GOVERNMENT OF THE DISTRICT OF COLUMBIA
DEPARTMENT OF TRANSPORTATION

MEMORANDUM

SUBJECT: ZC Case No. 18-13 – 1530 First Street SW

Figure 1. Site Plan (Source: Applicant's Statement in Support)

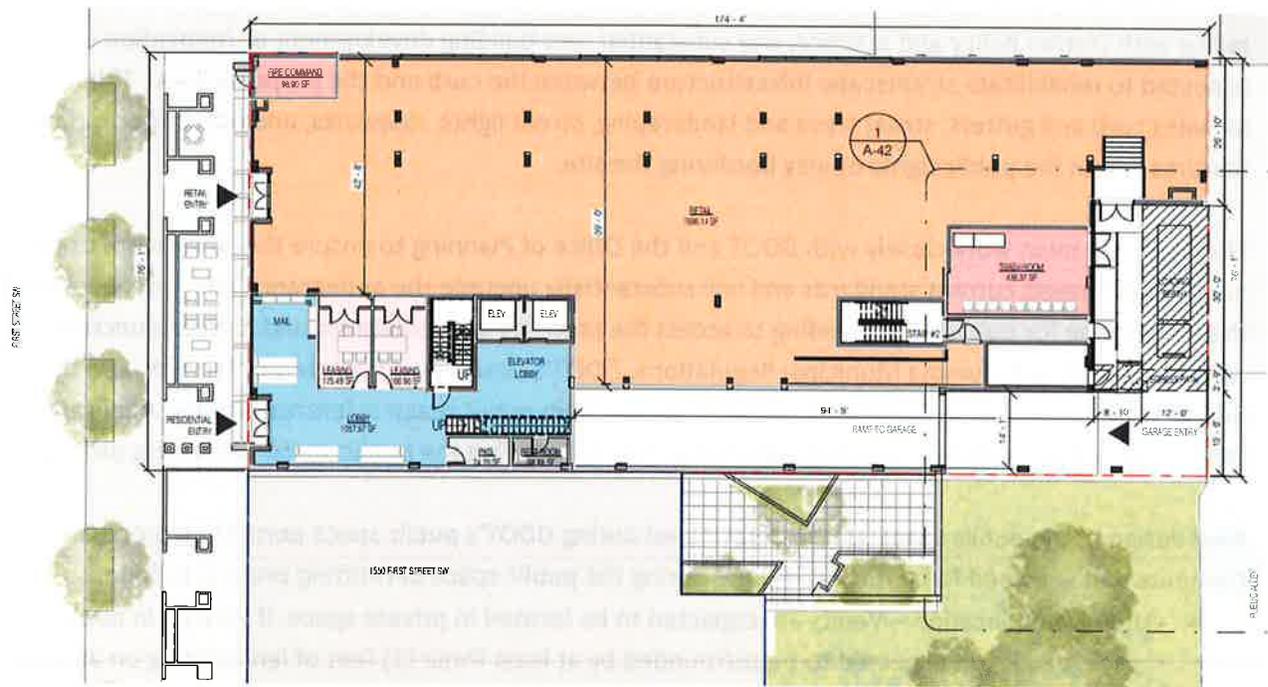
This site is bounded by First Street to the west, High Road Middle School to the north, a public alley to the east, and an approved multi-family development to the south (ZC Case No. 17-13). Access to vehicle and long-term bicycle parking is proposed via the adjacent public alley network, which connects to Half and Q Streets. Primary pedestrian access to the residential and retail uses is located on First Street. A site plan is shown in Figure 1.

Zoning regulations call for one (1) 30-foot berth and one (1) 20-foot service space to serve residential uses. The Applicant is requesting loading relief for the 30-foot berth due to the difficulty of accommodating a 30-foot truck in the existing public alley network. DDOT finds that the alley is capable of accommodating 30-foot trucks, however the limited alley frontage of the subject property is a challenge for larger trucks to access the site. The Applicant proposes to provide the 20-foot service space plus a 100 square foot platform that will accommodate commercially available rental trucks of up to 17 feet. Commercial rental truck companies advertise the 17-foot truck as appropriate for 2-3 bedroom homes and is therefore sufficient to meet the demand of the proposed unit mix in the subject development.
